COMMONWEALTH of VIRGINIA

August 3, 2015

MEMORANDUM

To: All Holders of the Virginia Department of Transportation's 2008 Road and Bridge Standards

PEDESTRIAN ACCESS ROUTE DETAIL WITH & WITHOUT UNPAVED SPACE

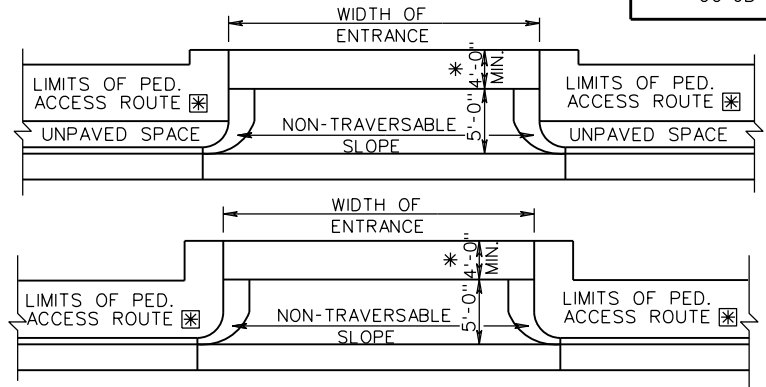
<u>PAGE</u>	<u>REVISION</u>
203.02	CG-9B added detail depicting pedestrian access route without an unpaved space.
203.03	CG-9D added detail depicting pedestrian access route without an unpaved space.
203.04	CG-11 revised text in section A-A from "8% slope change" to "8% grade change". Added note for pedestrian access route width & cross slope.

CG-12 DETECTABLE WARNING SURFACE

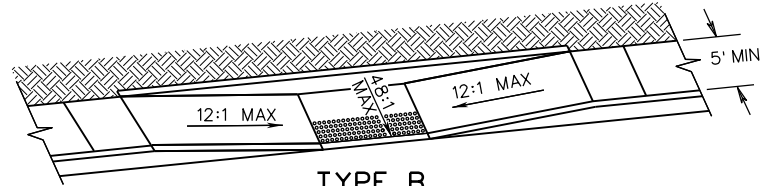
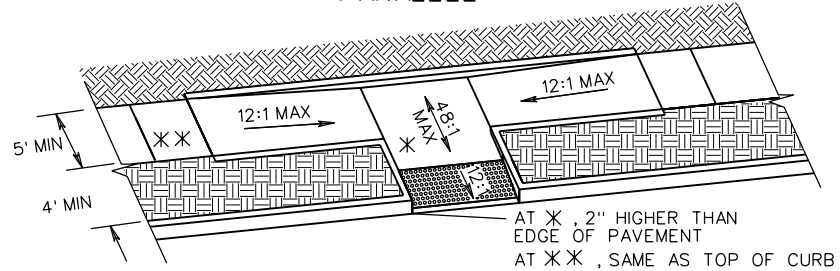
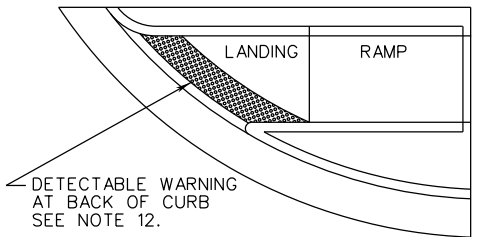
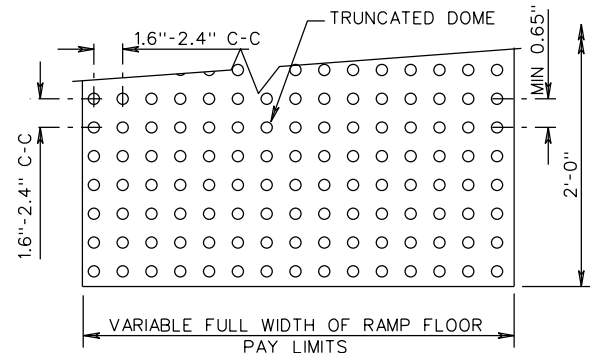
<u>PAGE</u>	<u>INTERIM</u>	<u>STANDARD</u>	<u>REVISION</u>
203.05	IIS02_01	CG-12	REVISED NOTE 2 TO STATE THAT DETECTABLE WARNING SURFACE IS TO BE SELECTED FROM THE MATERIALS APPROVED LIST. ADDED A NOTE LISTING THE PAY ITEM COMPONENTS OF THE STANDARD CG-12 CURB RAMP.

1. THE DETECTABLE WARNING SHALL BE PROVIDED BY TRUNCATED DOMES.
2. DETECTABLE WARNING SHALL BE FROM THE MATERIALS APPROVED LIST FOR DETECTABLE WARNING SURFACES. PRODUCTS NOT LISTED SHALL MEET THE REQUIREMENTS OF THE SPECIAL PROVISION FOR CG-12 DETECTABLE WARNING SURFACE AND SHALL BE SUBMITTED TO THE STANDARDS AND SPECIAL DESIGN SECTION FOR APPROVAL.

NOTE: COMPONENTS OF CURB RAMPS CONSIST OF THE FOLLOWING:
 HYDRAULIC CEMENT SIDEWALK (DEPTH IN INCHES, AREA IN SQUARE YARDS)
 CURB WHEN REQUIRED (CG-2 OR CG-3 IN LINEAR FEET)
 DETECTABLE WARNING SURFACE (AREA IN SQUARE YARDS)
 EACH OF THE ABOVE ITEMS IS A SEPARATE PAY ITEM AND SHOULD BE SUMMARIZED FOR EACH CURB CUT RAMP.

CG-12 DETECTABLE WARNING SURFACE
TYPE A (PERPENDICULAR) APPLICATION

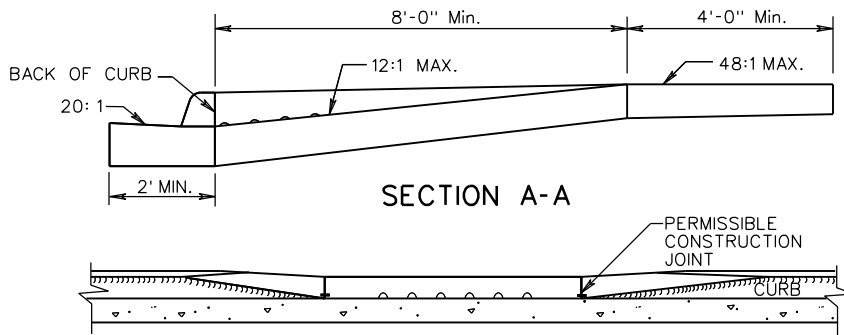
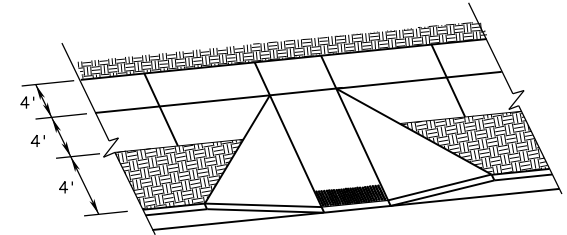
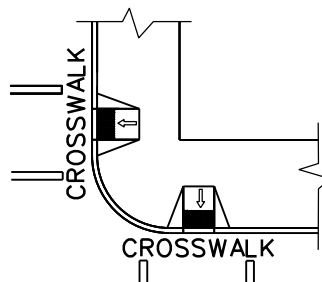
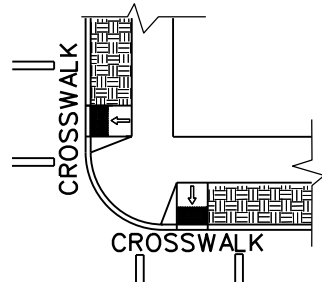
<u>PAGE</u>	<u>INTERIM</u>	<u>STANDARD</u>	<u>REVISION</u>
203.06	IIS02_02	CG-12	REMOVED "6 FEET FOR ALTERATIONS" FROM NOTES.
203.07	IIS02_03	CG-12	ADDED LABEL ON DETAILS AT BOTTOM OF PAGE TO CLARIFY THAT THE LANDING IS A 48:1 SLOPE.
203.08	IIS02_04	CG-12	ADJUSTED SECTION A-A TO SHOW THE ELEVATION DIFFERENCE BETWEEN THE RAMP AND LANDING.
501.39	IIS05_08	GR-INS	REVISED TABLE I TO INCLUDE 7' AND 5' TOTAL SHOULDER WIDTH. ADJUSTED NOTES SPECIFYING GR-2A WHEN DESIGN SPEEDS ARE GREATER THAN 45 MPH.
1310.12	IIS13_02	PF-8	REVISED ELEVATION FOR FOUNDATION ABOVE GRADE AND UPDATED NOTES
1310.13	IIS13_46	PF-8	REVISED ELEVATION FOR FOUNDATION ABOVE GRADE AND UPDATED NOTES
1324.10	IIS13_04	OSS-1	ADDED SECOND NUT TO DETAIL TO BE CONSISTENT WITH THE CURRENT SPECIFICATION REQUIREMENT TO PROVIDE TWO NUTS ON ANCILLARY STRUCTURES ABOVE THE BASE PLATE.

THIS DESIGN TO BE USED FOR CONSTRUCTION THAT INCORPORATES WIDER SIDEWALK. LANDING (4' WIDE) REQUIRED AT TOP OF CURB RAMP. MINIMUM CURB RAMP LENGTH 8 FEET FOR NEW CONSTRUCTION.
